**OHIO TURNPIKE AND
INFRASTRUCTURE COMMISSION**

ADDENDUM NO. 1

CONTRACT NO. 53-10-04 (RE-BID)

**SANITARY GRINDER STATION
MILEPOST 197.0
PORTAGE COUNTY, OHIO**

| SHEET 3 OF 5 | | | |

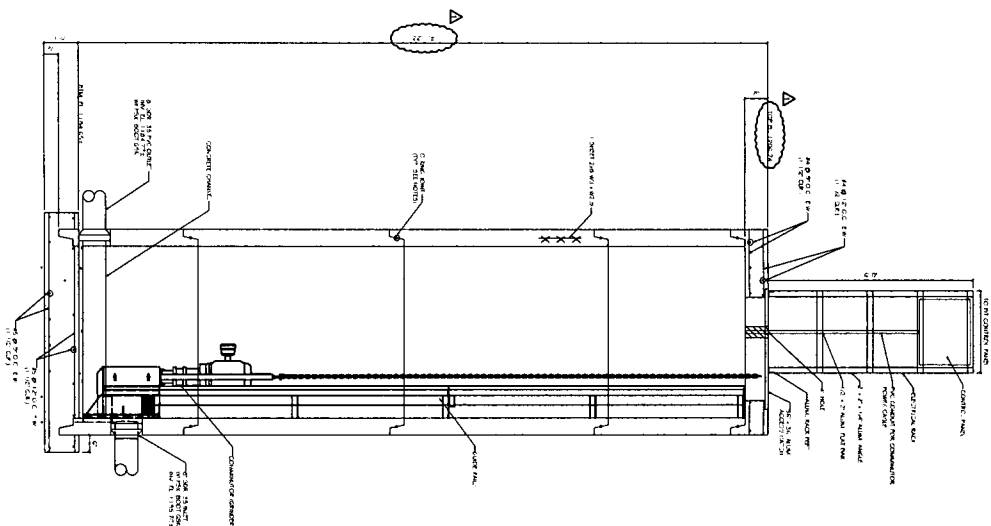
The top rim elevation for the wet well is modified from ~~1200.74~~ to ***1206.74***, and the depth of the wet well is modified from ~~16'-1" +/-~~ to ***22'-1" +/-***.
